ADAMSTOWN SDZ PLANNING SCHEME 2014

Proposed Amendments in response to New Planning Policy and Guidance

> Submission to An Bord Pleanála March 2020

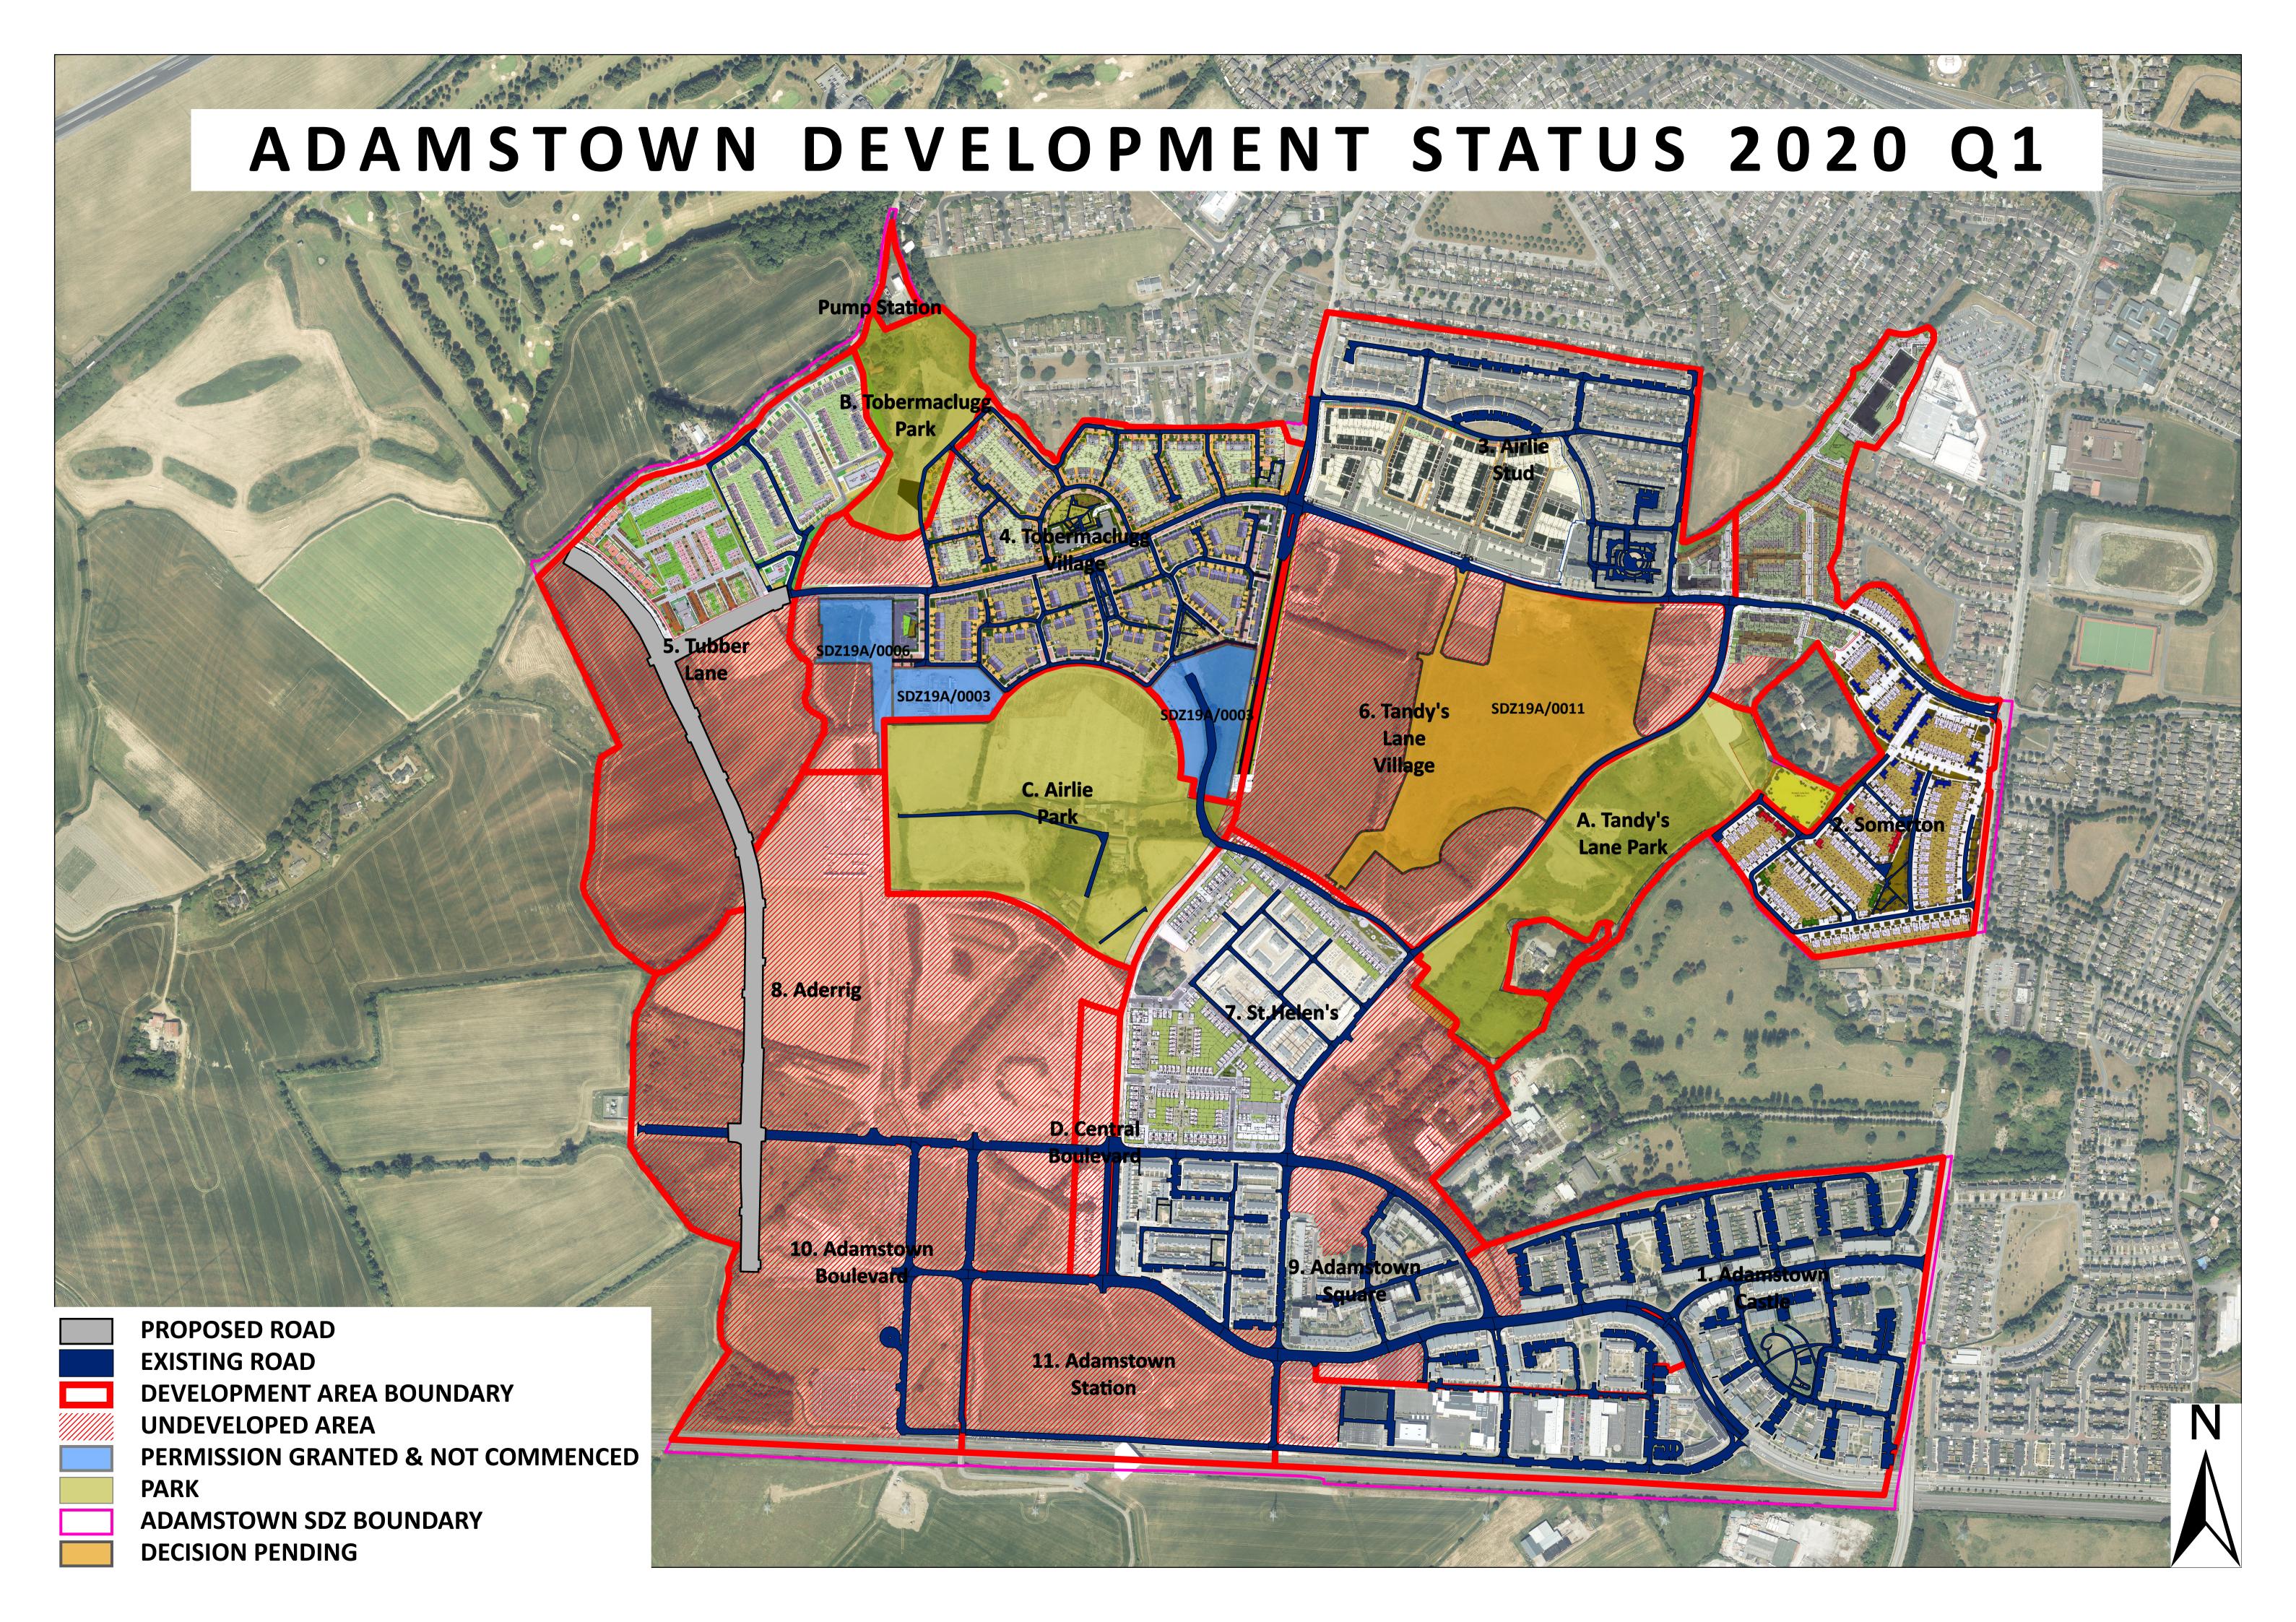
- Identify four protected structures with pentagon symbol and RPS reference number on all relevant maps within the SDZ Planning Scheme document.
- Add text 'Protected Structure' and pentagon symbol to key for each relevant map.
- Include pentagon symbol in map key.

- Airlie House (RPS Ref. 109) (included within SDZ Planning Scheme lands)
- Somerton House (RPS Ref. 107) (not included in SDZ Planning Scheme lands)
- St. Helen's (RPS Ref. 108 (not included in SDZ Planning Scheme lands)
- Finnstown House (RPS. 112) (not included in SDZ Planning Scheme lands)
